Proposal for an amendment to UN Regulation No. 43 to define a *reduced vision zone I* for vehicles of categories M and N other than M₁

I. Proposal

Annex 3

Figure 11

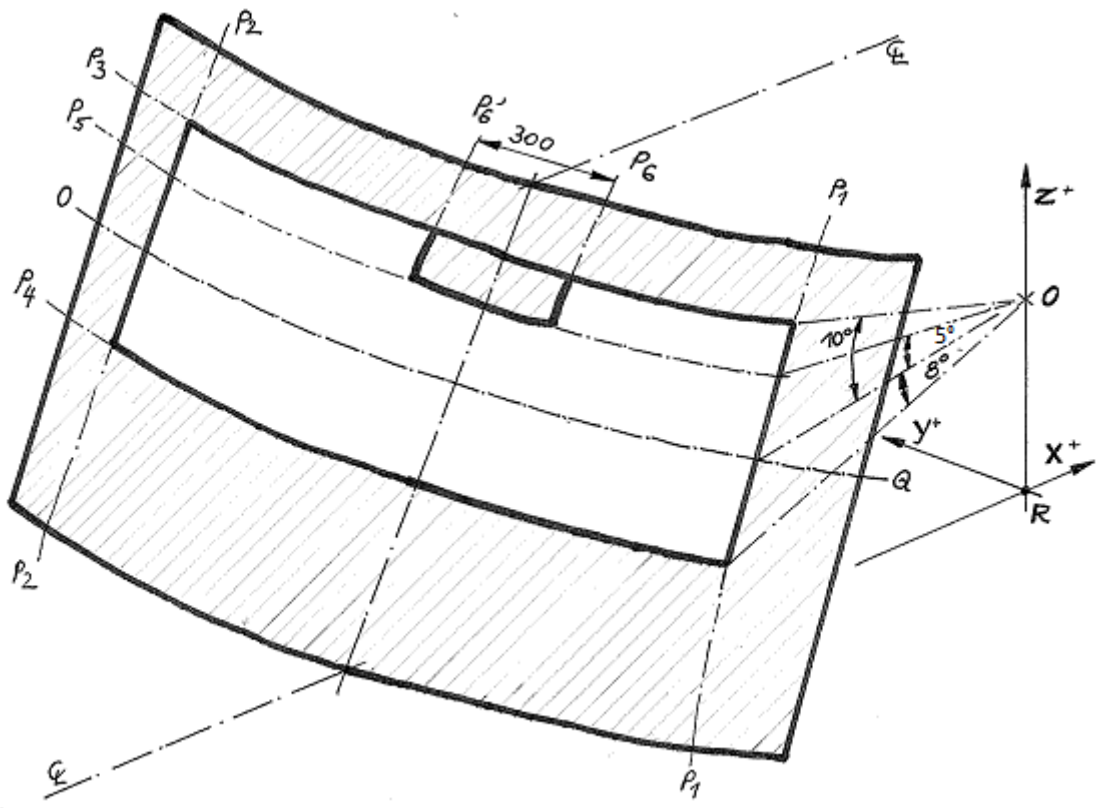
- 9.2.5.3. The reduced test area I is the test area I as defined in 9.2.5.2.3 with the exclusion of the following area (see figure 11).
 - 9.2.5.3.1. Any opaque obscuration bounded downwards by plane 5, a plane passing through the straight line OQ and forming an angle of 5° above the horizontal plane and laterally by planes 6 and 6', vertical planes parallel to the longitudinal median plane of the vehicle in a distance of 150 mm to the trace of the longitudinal median plane of the vehicle (CL)⁹.

⁹ Measured on the outer surface of the windscreen and on the trace of plane 5.

If this is not possible (in the absence of a symmetrical median longitudinal plane, for instance) P6 and P6' shall be the planes parallel to the longitudinal plane of the vehicle passing through point 0.

The proposed angle of 5° (proposed annex 3, para. 9.2.5.3.1.) to define an area analogical to the above will lead to a range in the distances p3-p5 on CL (see Figure 11) of approximately **50 – 85** mm (basis for this estimation are 10 trucks and a bus with windscreen inclination angles of 7,2°-31°). Laterally the limit is set at 300 mm.
